Corporal Arthur Nelson Play Lot Renovation Project (Fuller Street Park)  
Project Number: DPW-26-58

**ADDENDUM NO. 1**

February 3, 2026

DESCRIPTION:	MODEL #:	DATE:	JES DESIGN #:	REV:
16' Hexagon Post & Beam	HPB16	3/25/2019	HPB-STNRD	0

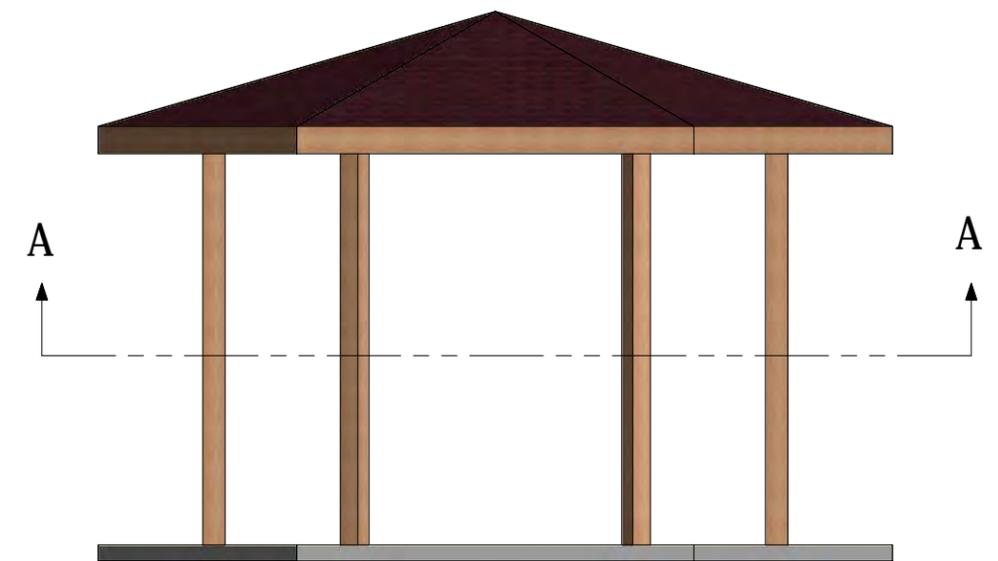
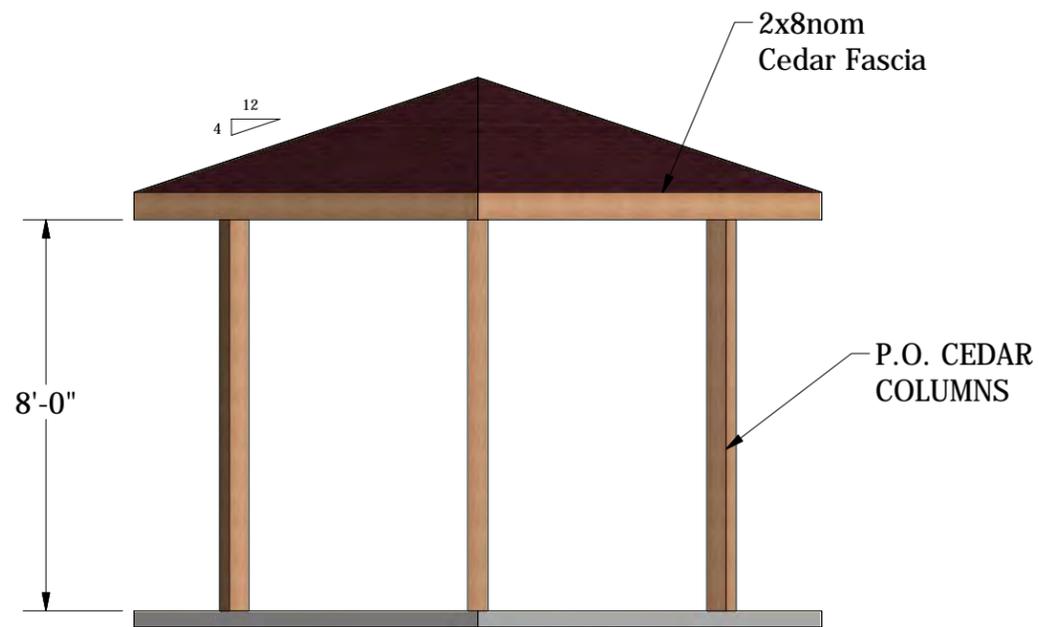
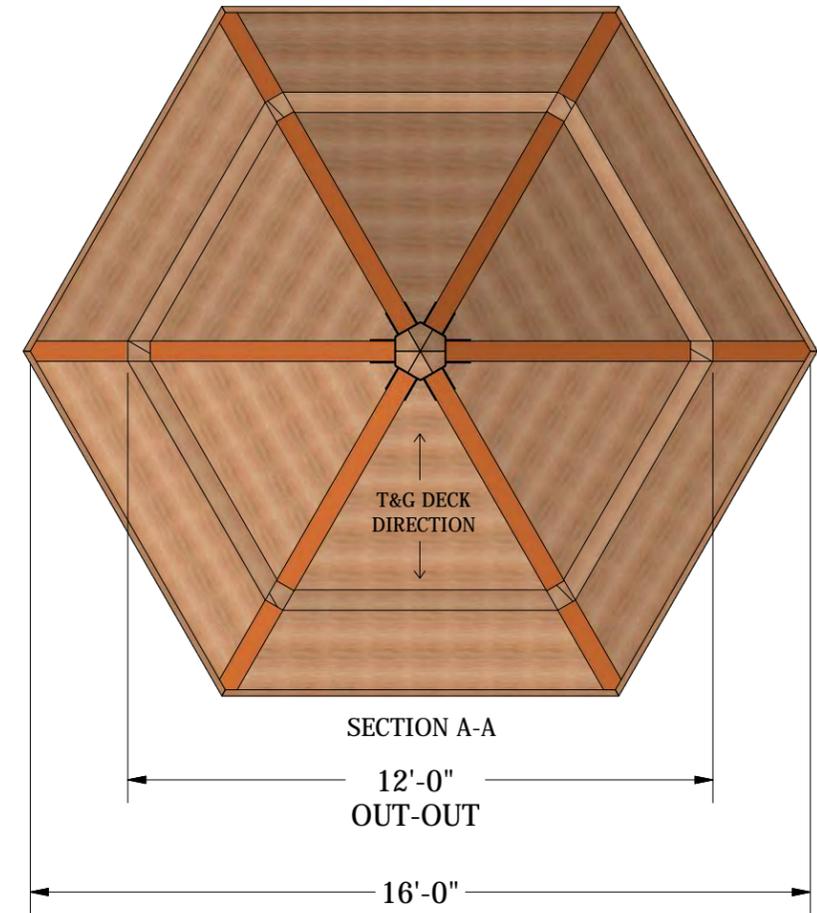
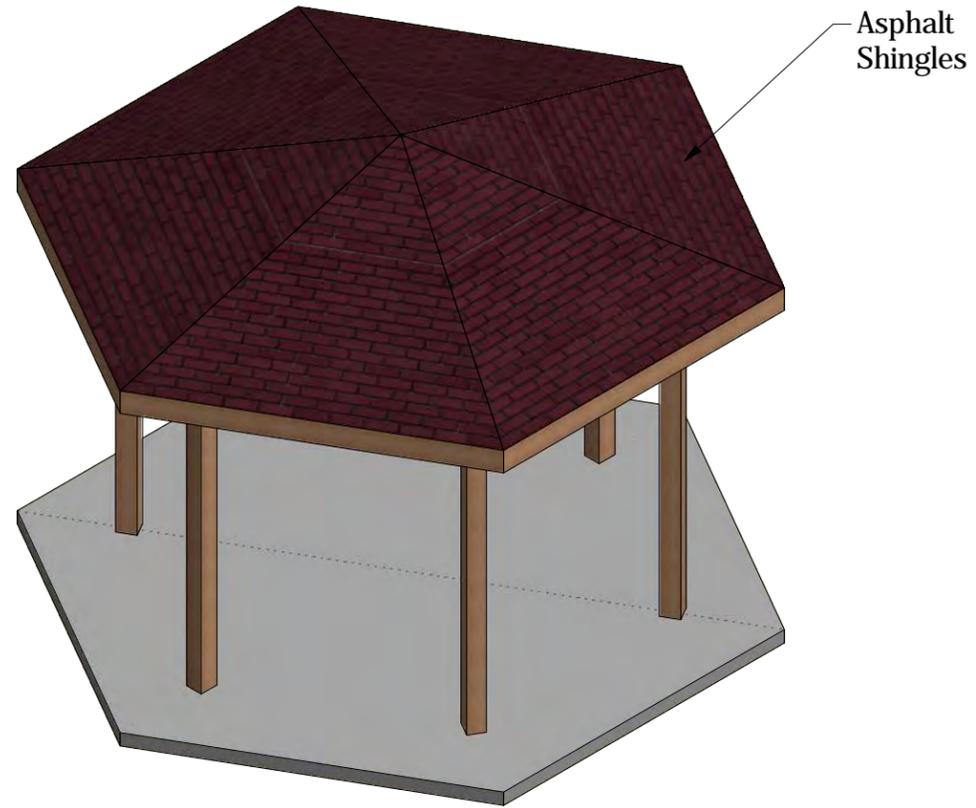
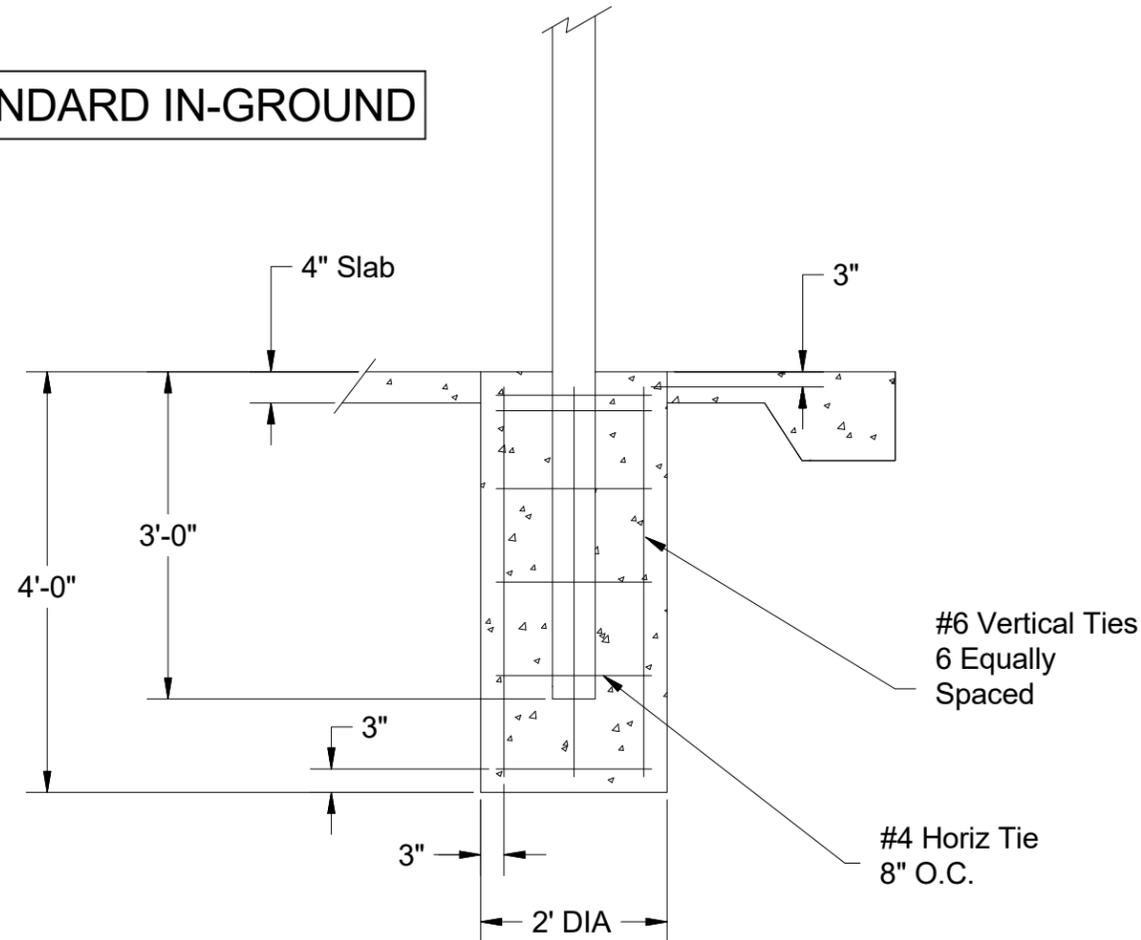
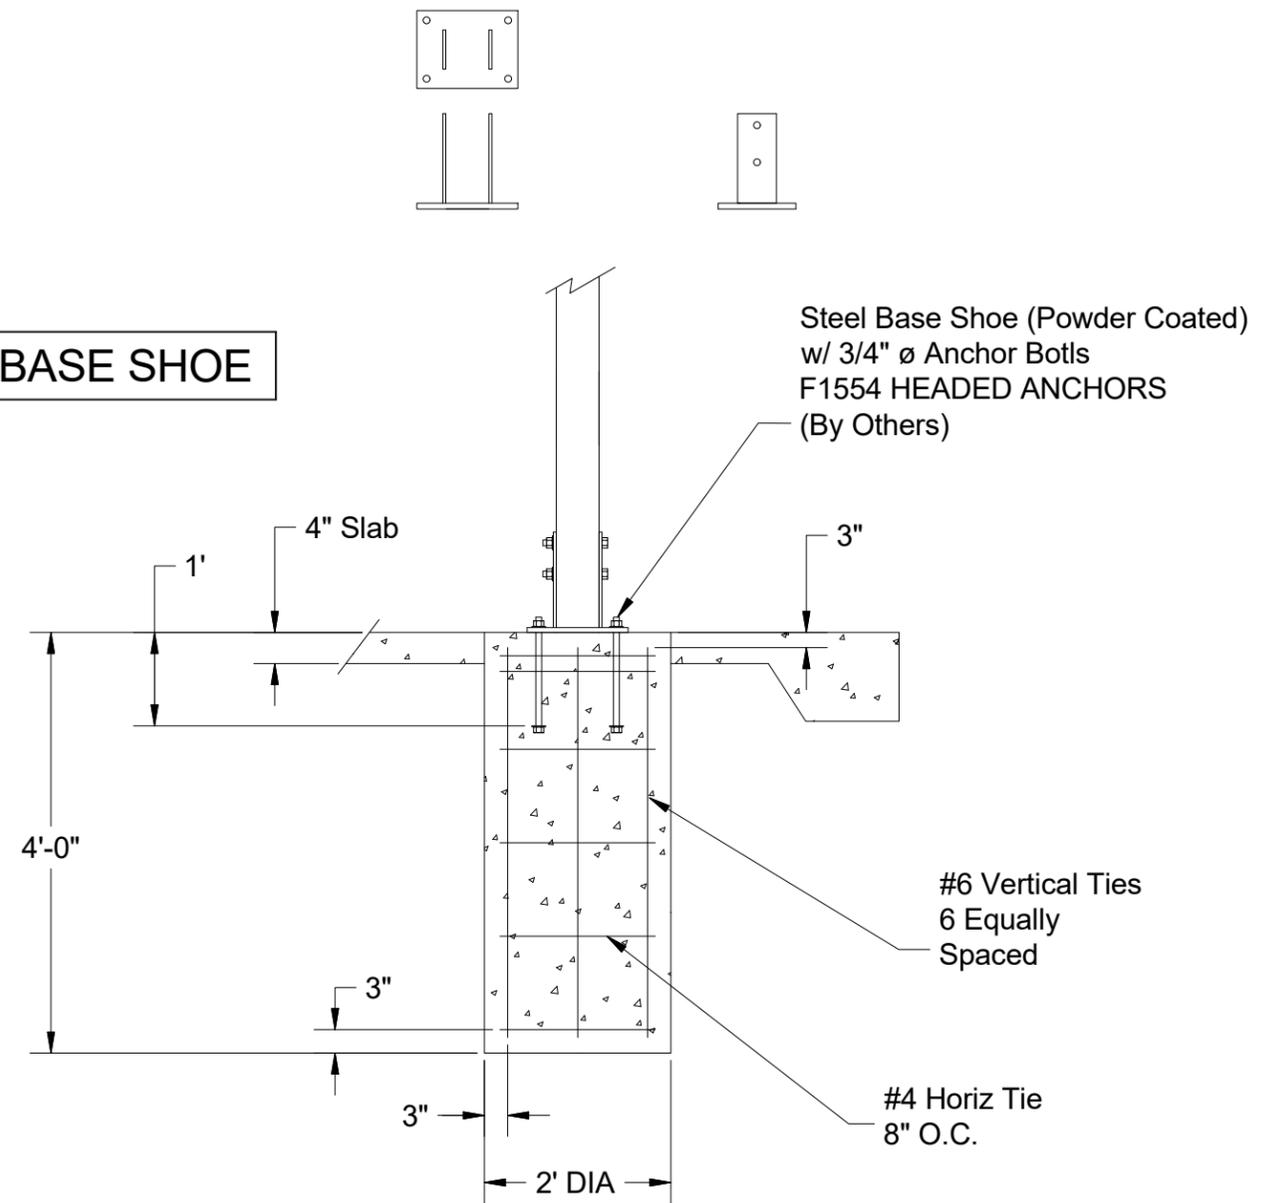
2. Updated Shade Structure. See attached details.
3. Contractor shall install City of Everett water meter in an oversized splash pad control cabinet Model No. EC20 as manufactured by Vortex, or approved equal. Contractor is responsible for all materials, testing, and coordination with the City to provide a fully functioning system. See attachments for more information.

**CONTRACTOR TO HAVE FOOTINGS TO BE STAMPED BY STRUCTURAL ENGINEER PRIOR TO INSTALLATION.**
